Technical Service Bulletin

**ENGINE RUNS ROUGH AND CHECK ENGINE LIGHT ON WITH DTCS
P0201 AND P0204 OR P0202 AND P0203**

Bulletin No.: 01-004/17

Last Issued: 07/05/2017

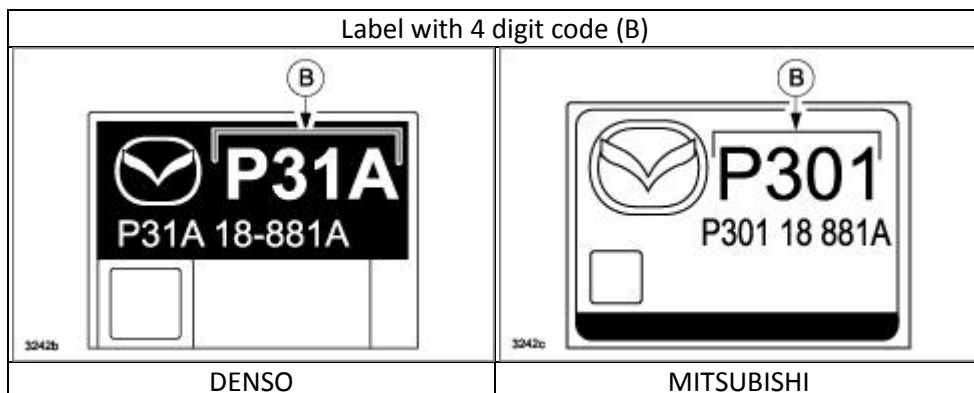
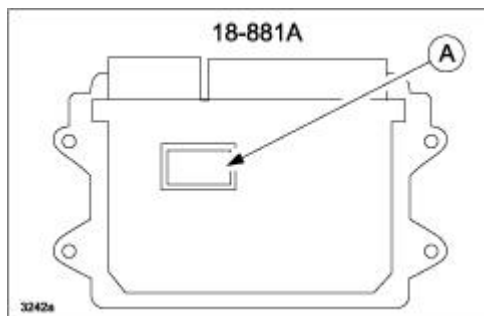
2. Check if the PCM is "DENSO" produced. Inspect the PCM label (A) and check the 4-digit code (B) to confirm this code matches with the first 4 digits of DENSO PRODUCED PCM part numbers specified in the GEPC.

- CX-5: PCM REMOVAL/INSTALLATION [SKYACTIV-G 2.0, SKYACTIV-G 2.5]
- Mazda3: PCM REMOVAL/INSTALLATION [SKYACTIV-G 2.0, SKYACTIV-G 2.5]
- Mazda6: PCM REMOVAL/INSTALLATION [SKYACTIV-G 2.5]
- If the PCM is "DENSO", replace the PCM according to the instructions on MS3 online.
